Plan Review Comments - 101 W. 33rd Street

Plan Review Comments for 101 W. 33rd Street – Marco Polo

12. Sheets S0.2 and S0.3

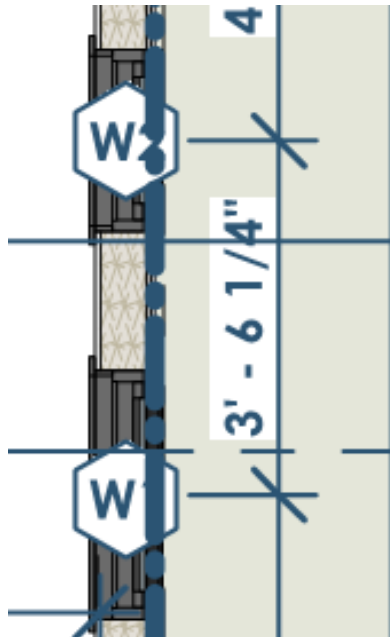
- a. There's a callout for Detail / Section 6A on Sheet A500 but there isn't a detail 6A on that sheet.

17. Sheet A301

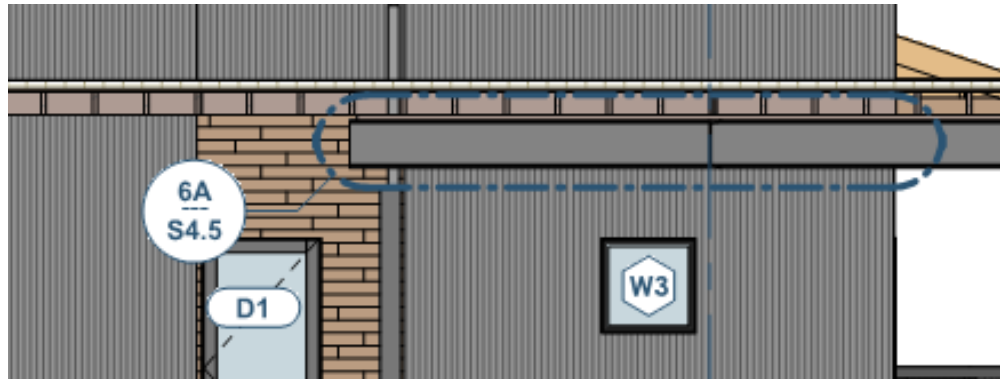
- a. You might consider moving these callouts because in the black and white sheets, they're getting lost in the exterior materials.

19. Sheet A410

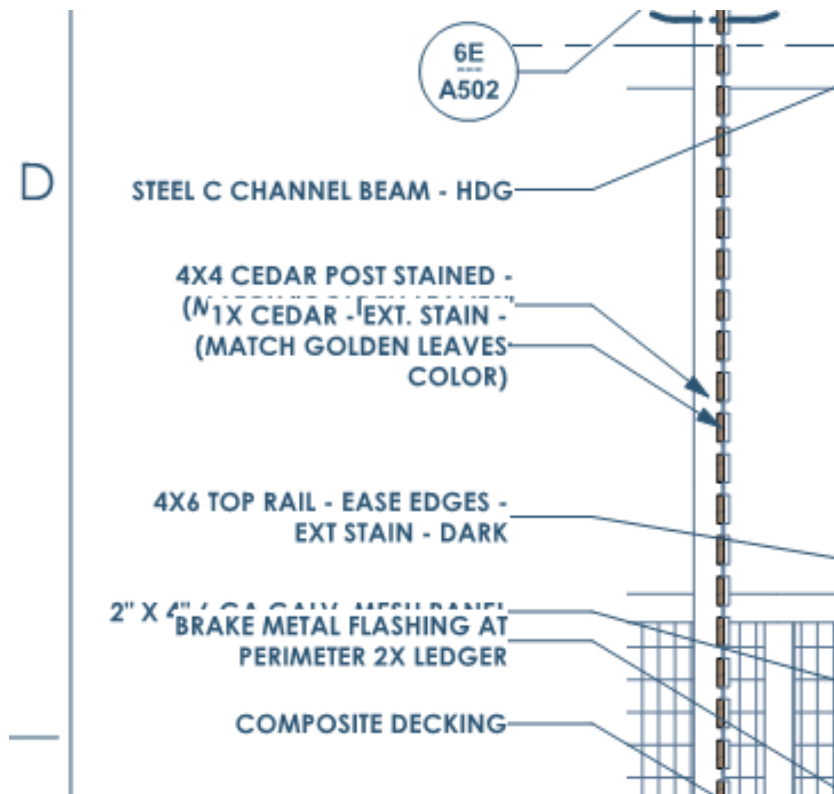
- a. 3A – Stair Section - There are several references to Section 6E on Sheet A502 but there isn't a Section 6E on that sheet. It may need to be revised to Sheet A503.
- b. Will the shop drawings for the prefab stairs be a deferred submittal? We will need more dimensions on the stairs.
- c. Please clean up this text –

23. MEP Sheets

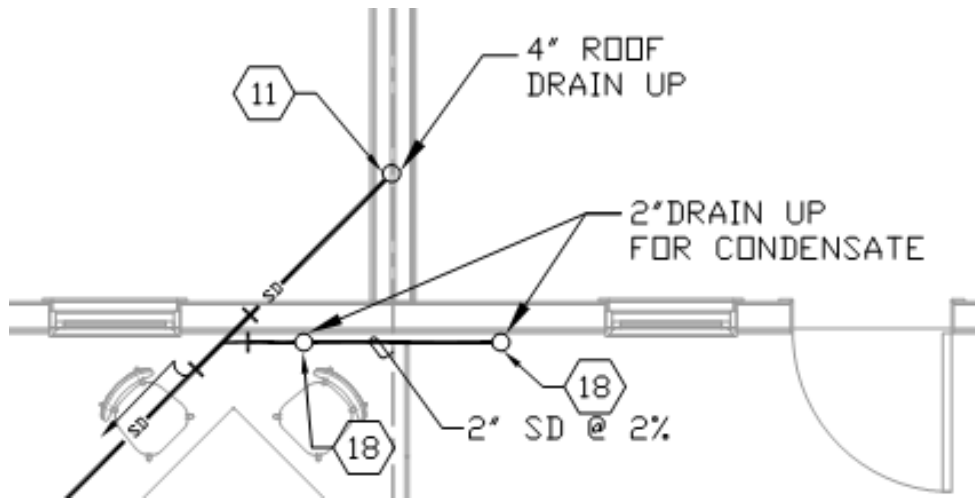
- a. Please add your Texas Firm Registration Number to the title block.
- b. Please use and reference the 2015 International Codes, 2020 NEC and Bryan's Amendments to the adopted codes.
- c. Please send a list of any deferred submittals to the architect so they may be placed on the Cover Sheet with the rest of the deferred submittals.
- d. Please make a note on the appropriate details that all condensate must be routed to the sanitary sewer. The roof drains may be routed to the storm sewer but condensate must be routed to the sanitary sewer.
- e. Please note on electrical plans the maximum available fault current per Article 110.24 of the 2020 NEC. Needs to include date the calculation was made. Required
